Niagara
Escarpment
Commission

Re: Supplementary Review of Additional Information
submitted by the Regional Municipality of Halton,
Landfill Component Environmental Assessment
E.A. File No. 1-82-0006-000/MU-0290

Re: Waste Management Environmental Assessment
Regional Municipality of Halton
E.A. File No. I-82-006-000

Re: Regional Municipality of Halton
Waste Management Environmental Assessment
E.A. File No. 1-82-006-000

SITE 'D' SKETCH PLAN OF PROPOSED SANITARY LANDFILL SITE

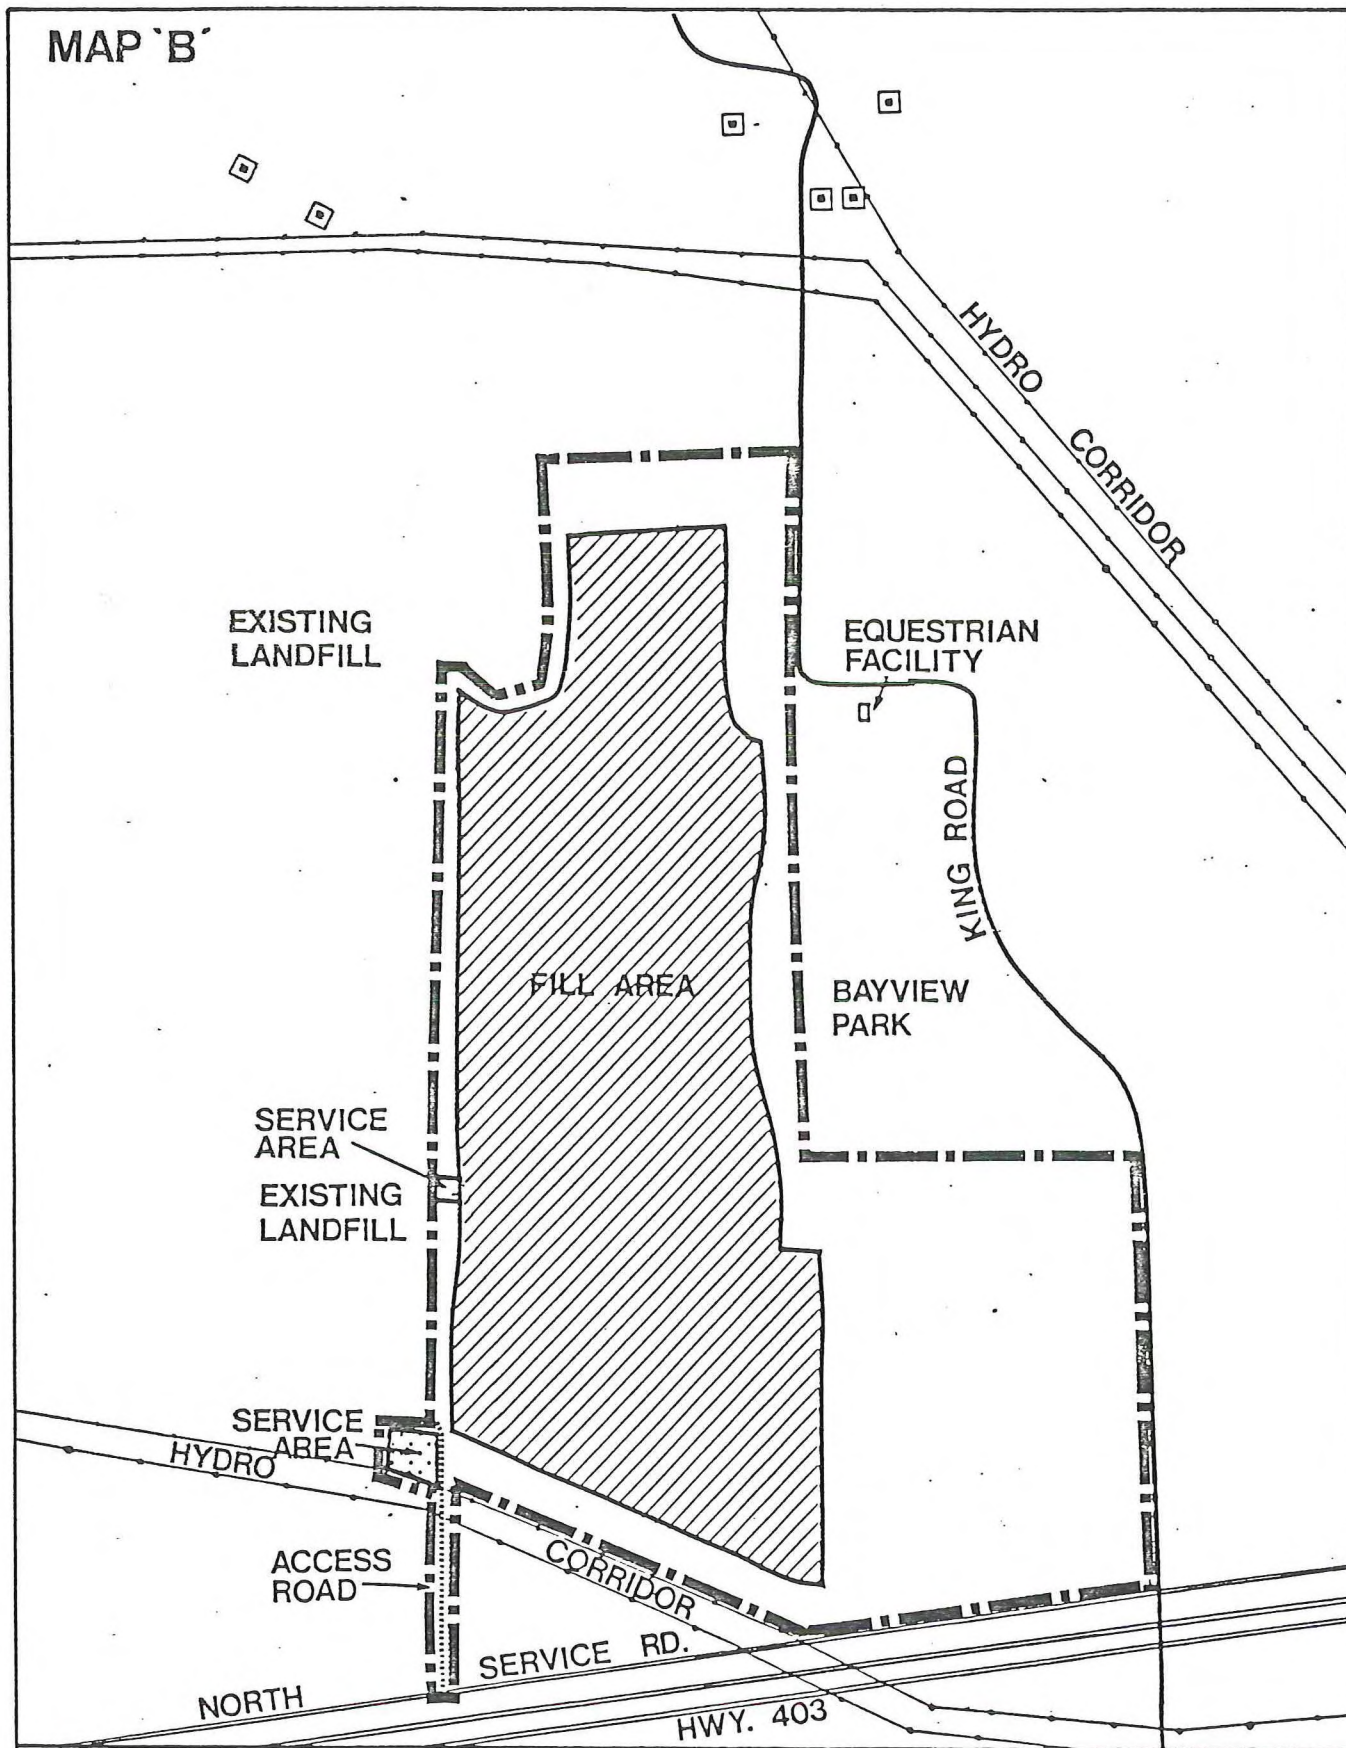
With respect to Public Health and Safety, the consultants preferred Site F over Site D by a small margin. Under the category of Natural Environment, the agricultural impact at Site D is proposed to be moderated by the after use. Alternatively, there are major biological impacts with Site F. On balance, the consultants concluded that Site D may be marginally preferable when the Natural Environment is considered.

With respect to the Social Environment, Site F is preferred in particular when the sub-categories of population impact, land use compatability and visual impact is considered. Similarly, Site F is preferred with respect to the Cultural Environment and in particular heritage resources. No preference is given where costs, engineering and Operations are concerned.

MAP B

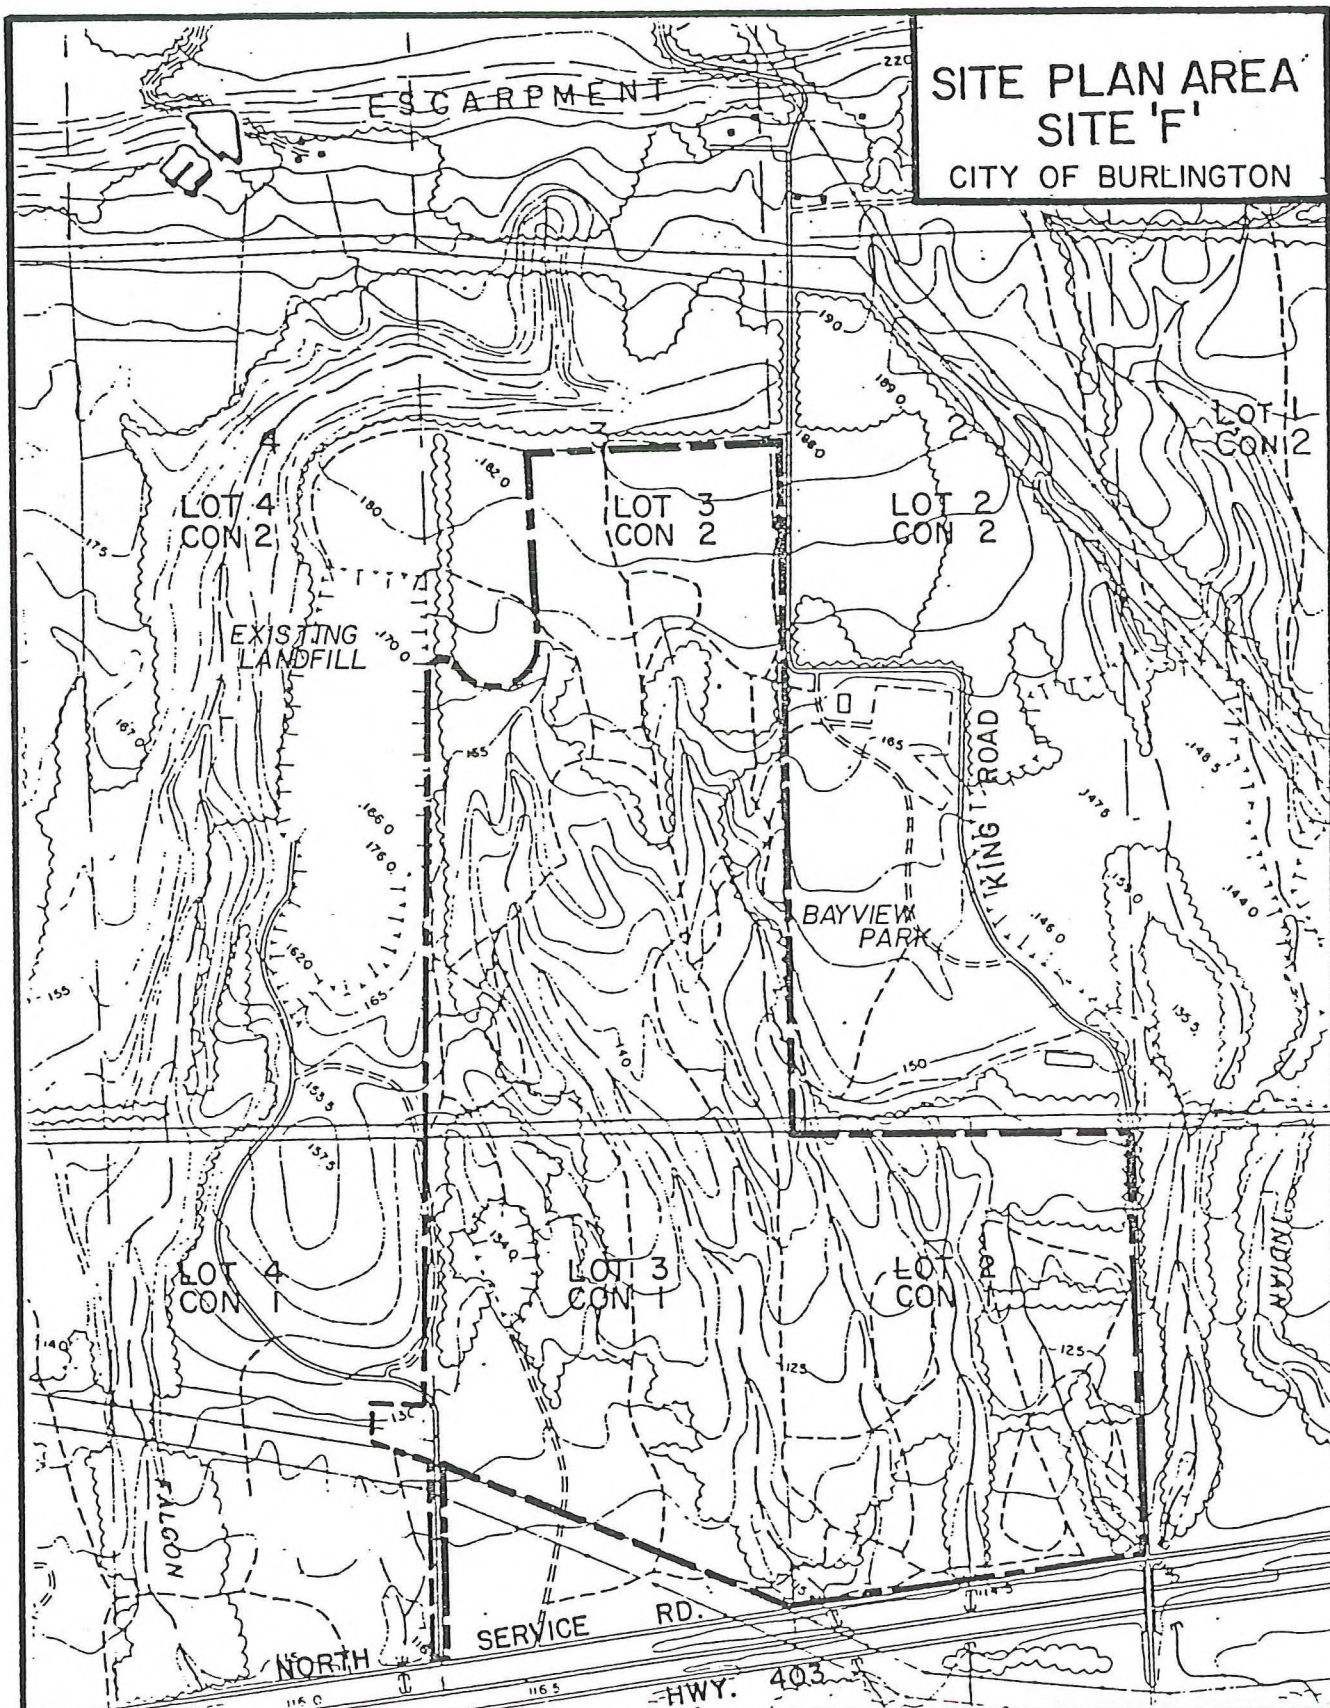
1. The south, east and west sides of the site should be heavily screened with vegetation to reduce visual impacts on Bayview Park, the existing Regional landfill site and views from the south.

2. The height of the landfill should be kept as low as possible to allow visual access to the Niagara Escarpment from south of the site.
3. The existing woodlots and hedgerows adjacent to the boundary of the site should be preserved and incorporated into an overall planting scheme.

4. Progressive rehabilitation along the side slopes of the landfill will help to screen the site.
5. Continuation of rehabilitation of the existing Regional landfill site will help screen views from residences in the northwest.

6. The service area should be set back and screened from either the north Service Road or King Road.
7. The top of the landfill should reflect topographic variation similar to the surrounding "natural slopes" of the foot of the Niagara Escarpment.

In terms of after use, the Region's consultant has recommended that the site be revegetated with natural forest cover in character with the Escarpment slopes to the north, east and west. Passive recreation trails are recommended to link the site with other Escarpment public open spaces.

In the opinion of staff, the concerns raised previously about groundwater and surface water, visual impact and biophysical resources have been adequately dealt with in the supplementary reports and in the Design and Operations Report.
